**2020 CMOM Package 3 (Applewhite)  
Solicitation Number: CO-00548  
Job No.: 20-4519**

**ADDENDUM 1  
August 12, 2022**

**2020 CMOM PACKAGE 3 (APPLEWHITE)**  
**LINE A - PLAN AND PROFILE SHEET**  
 STA 29+00 TO STA 33+00

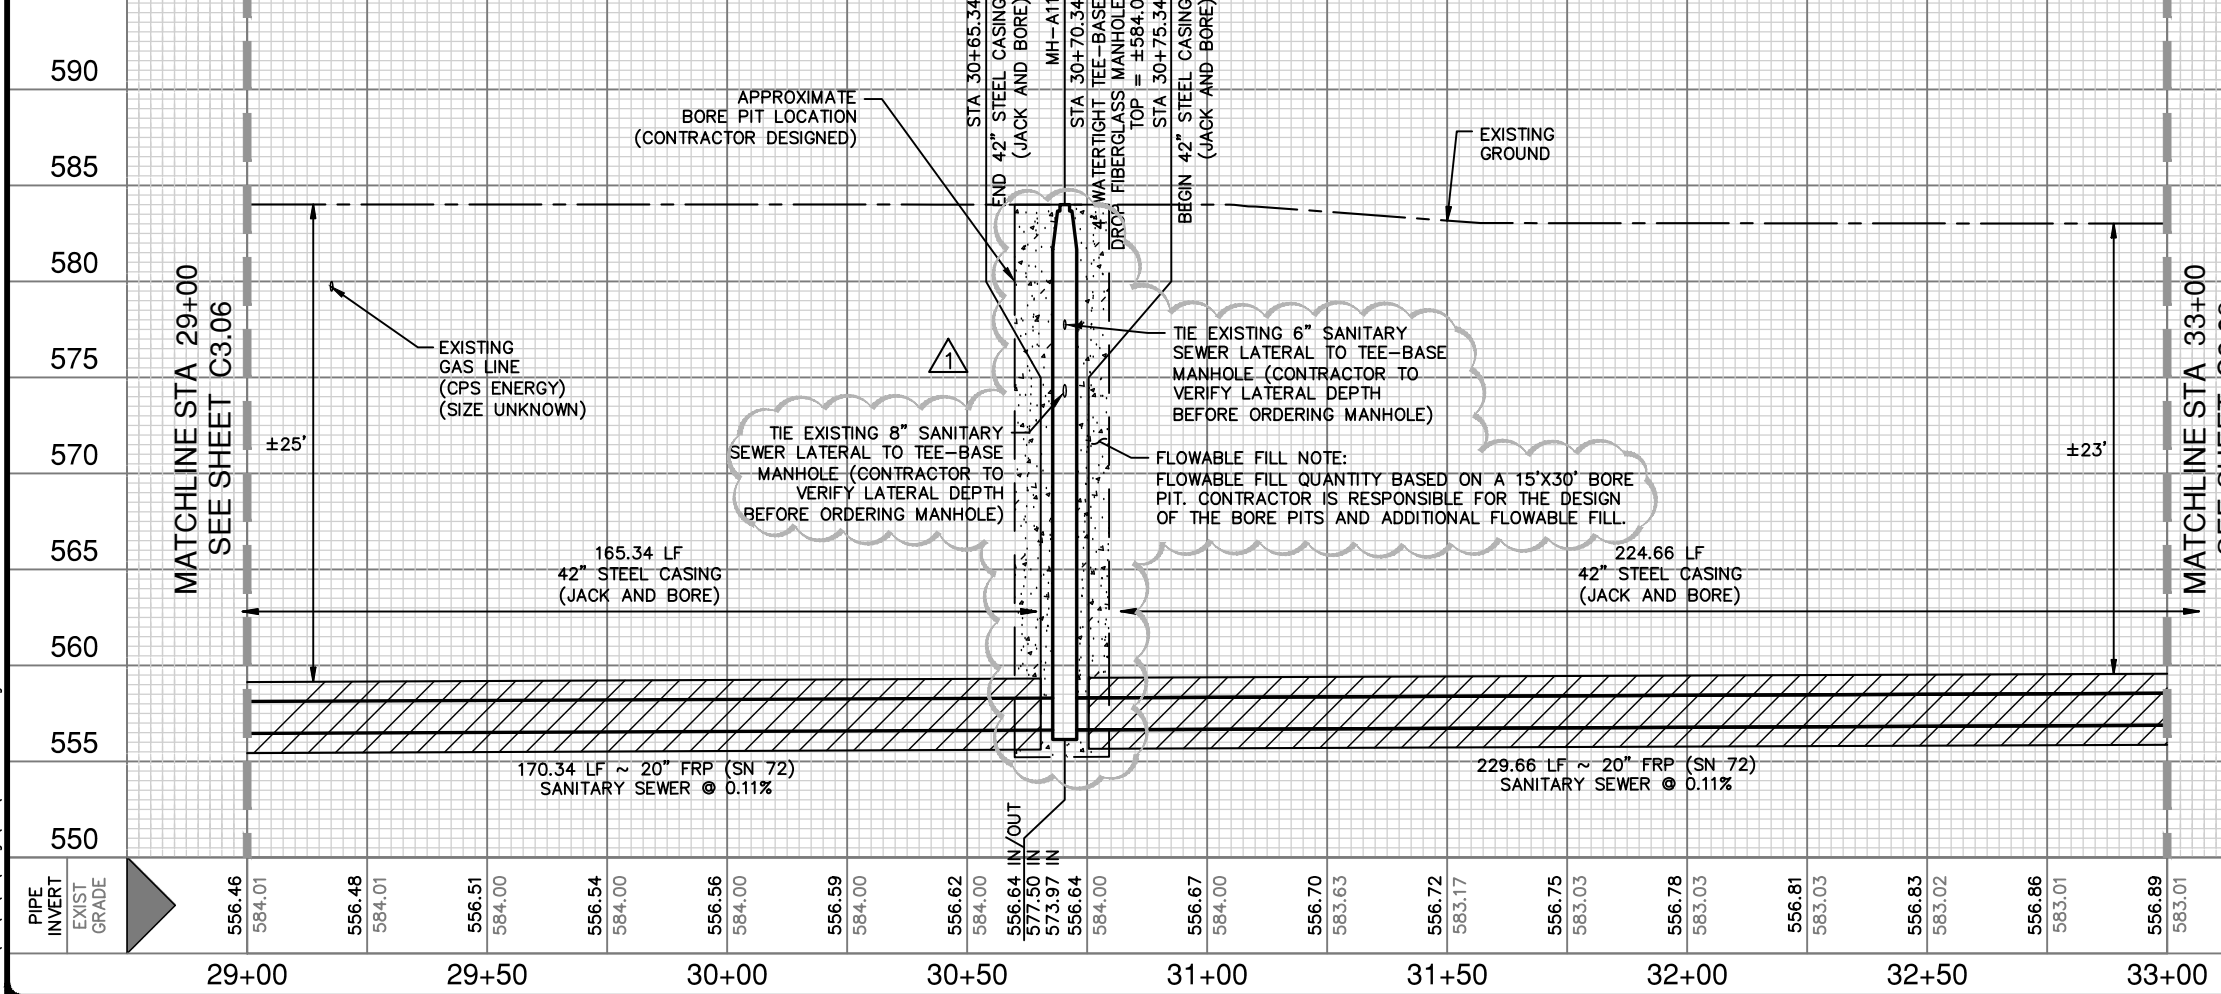
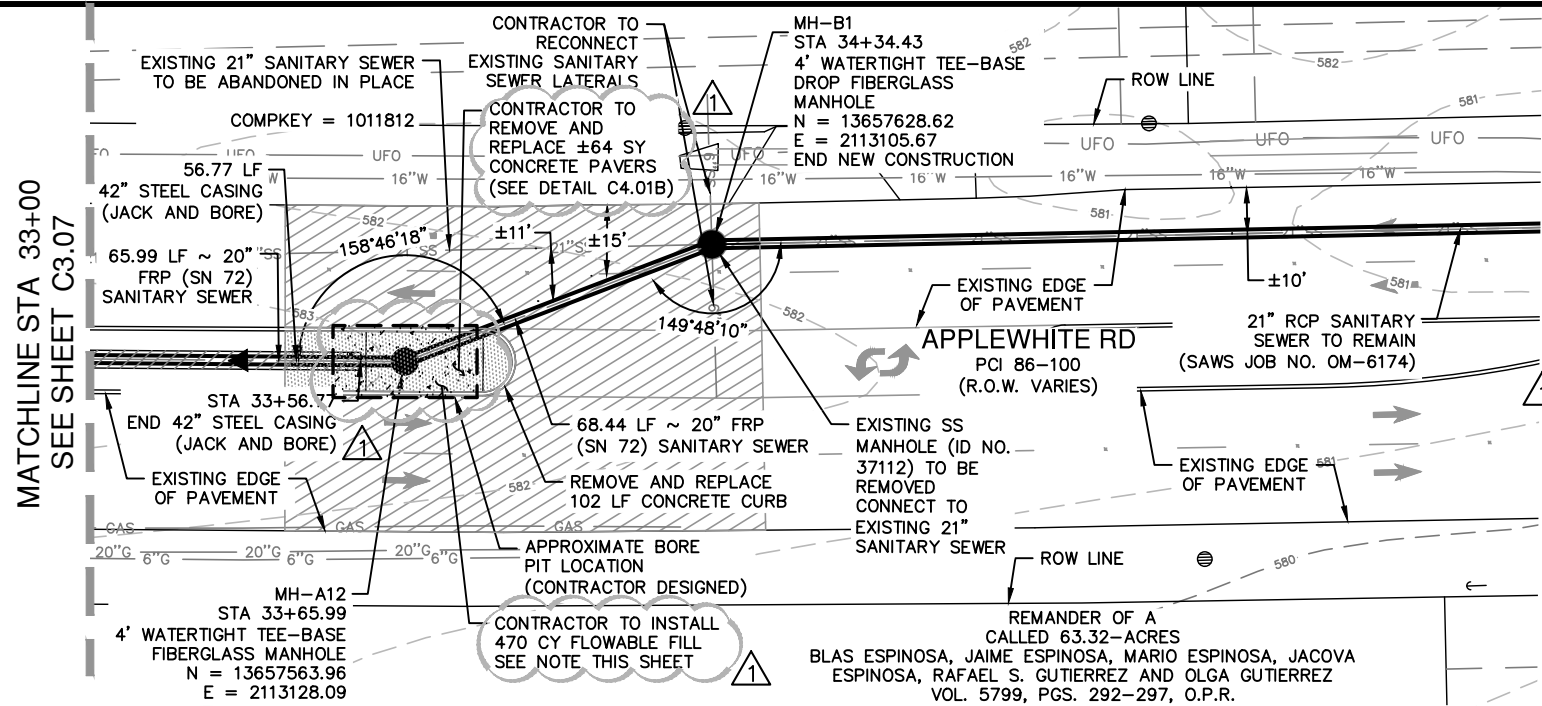
- 3. For the bore pits being on the road and so close to the existing sewer line, can you provide flowable fill backfill bid item. It will be difficult to compact after installation of manhole and with those depths the existing pavement will cave in if you try to compact the bore pits.**  
*Additional flowable fill has been added to the plans and quantities to account for backfilling of the proposed bore pits on sheet C3.04, C3.05, C3.06, C3.07, and C3.08.*

7. Sheet C3.07: Line A – Plan and Profile Sheet Sta 29+00 to Sta 33+00 – Remove in its entirety and replace with the attached document.
  - Added Flowable Fill quantity and note, added Two-way Sanitary Sewer Cleanout, Sanitary Sewer Lateral 6” and Sanitary Sewer Lateral 8” quantities, removed Open Cut Lateral Reconnection quantity, revised Hot Mix Asphaltic Pavement – Type D, Tack Coat, and Salvaging, Hauling and Stockpiling Reclaimable Asphaltic Pavement quantities

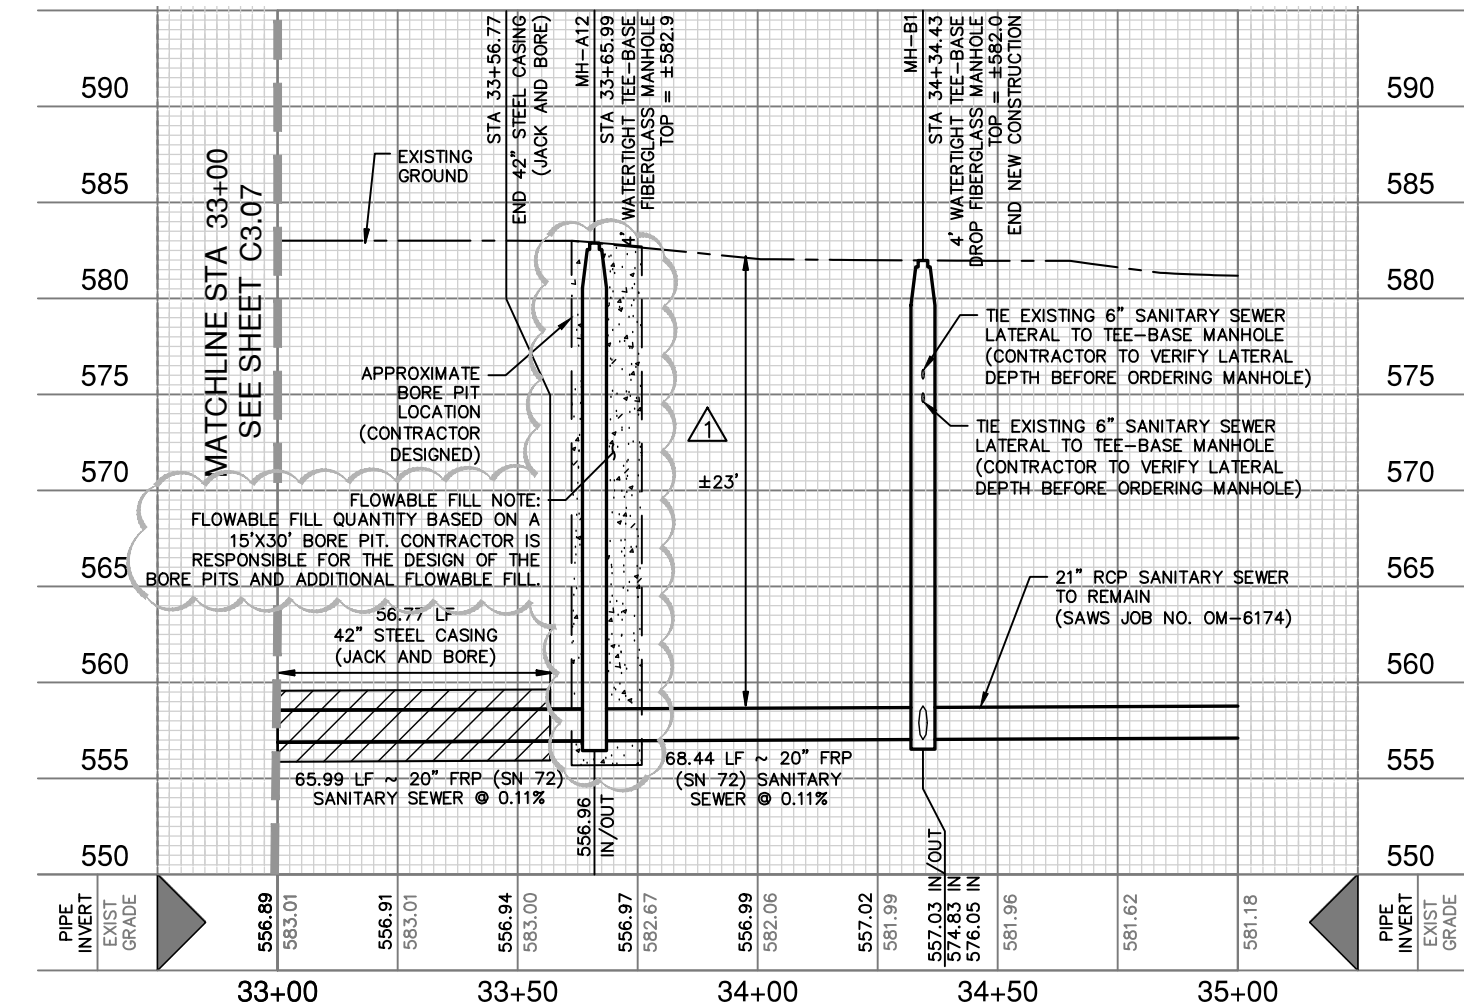
8. Sheet C3.08: Line A – Plan and Profile Sheet Sta 33+00 to Sta 34+58.99 – Remove in its entirety and replace with the attached document.
  - Added Flowable Fill quantity and note, revised concrete paver callout

**2020 CMOM PACKAGE 3  
(APPLEWHITE)  
DETAIL SHEET**

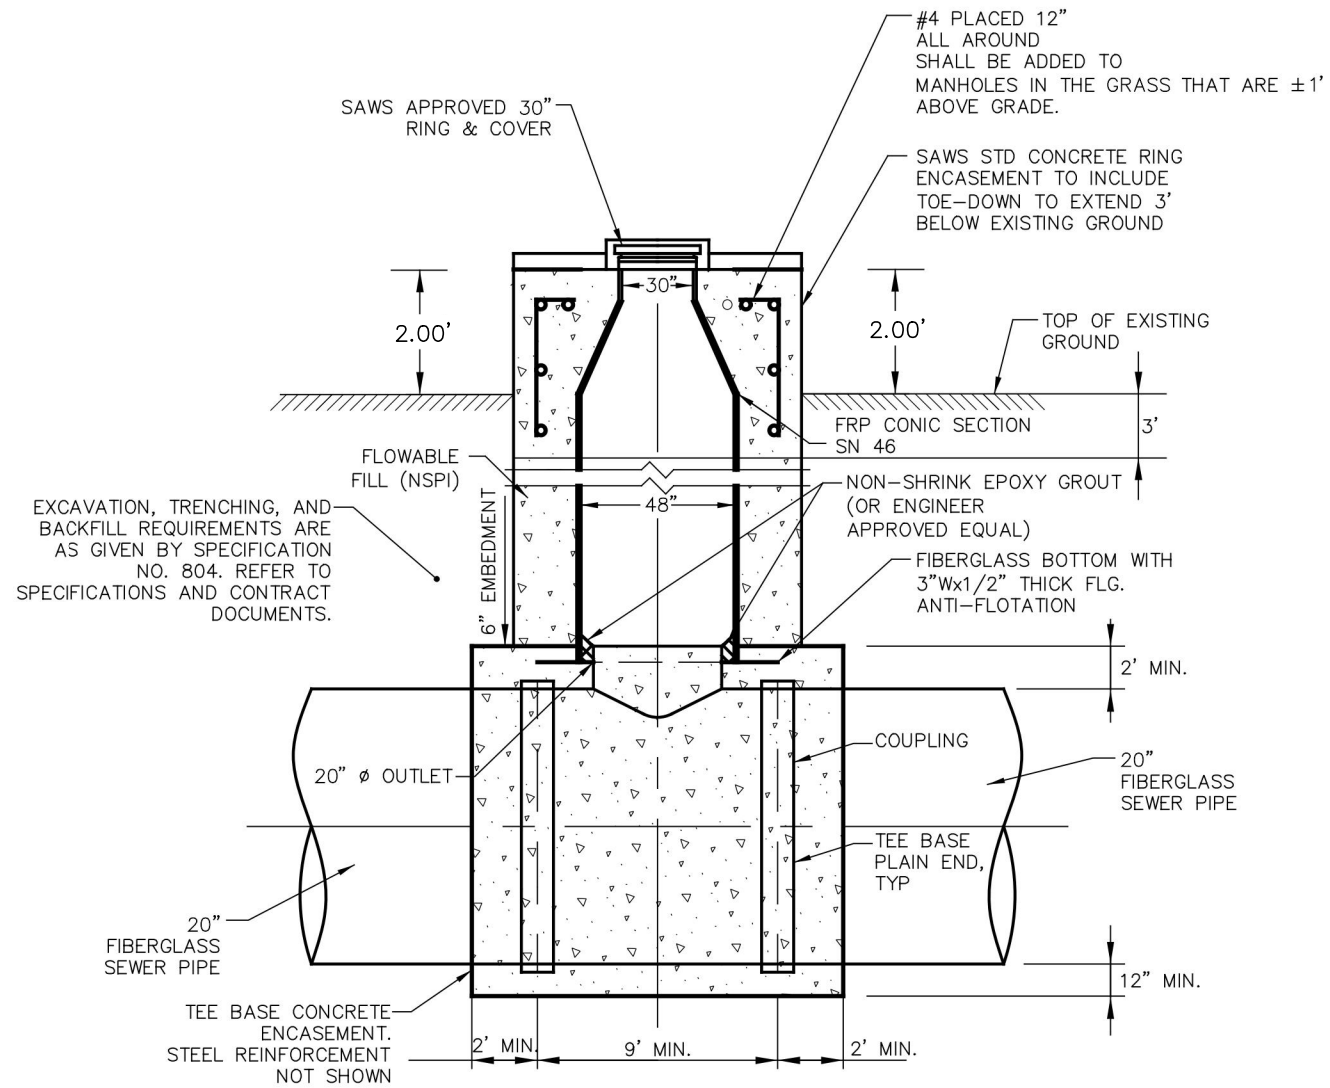
- 5. Is there any additional information on the concrete pavers? The CoSA spec referenced is for concrete sidewalks and it doesn't talk about concrete pavers and there isn't anything in the plans that shows a detail for the pavers.**  
*Concrete pavers to match existing pattern and color as shown in detail C4.01B.*

9. Sheet C4.01: Detail Sheet – Remove in its entirety and replace with the attached document.
  - Added Detail C4.01B: Existing Concrete Pavers
